Reply to Office Action of: 09/30/2008

REMARKS

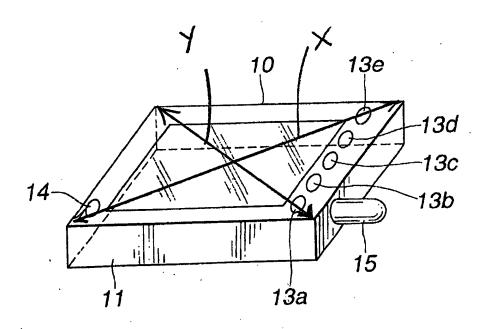
Claim 3 has been cancelled and its features have been added to claim 1. Claim 1 now claims that the face has one elongate diagonal and one truncated diagonal. Figs. 5 and 8 of Sekine et al. merely appear to show a face having a box-like rectangular shaped face. Thus, as shown below in the marked-up illustration of Fig. 8, in this perspective view the diagonal X appears to be the same size as the diagonal Y.

There is no disclosure or suggestion of X being larger than Y. This is merely an optical illusion from the perspective view. Claim 1, on the other hand, claims that the face has one

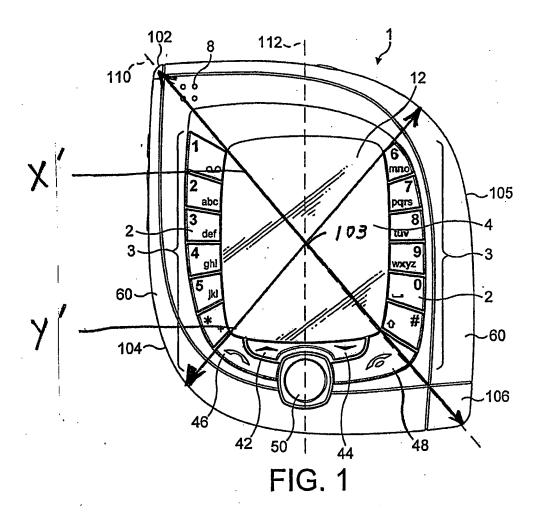
elongate diagonal and one truncated diagonal. As can be seen from the marked-up Fig. 1 below showing a front plan view of one embodiment of the casing, diagonal X' is longer than diagonal Y'. X' is an elongated diagonal of the face. Y' is a truncated diagonal of the face.

There is no disclosure or suggestion in Sekine et al. of applicants' claimed face having one elongate diagonal (such as X' shown above) and one truncated diagonal (such as Y' shown above). Therefore, claim 1 is not obvious in view of Sekine et al. Claim 1 is patentable and should be allowed.
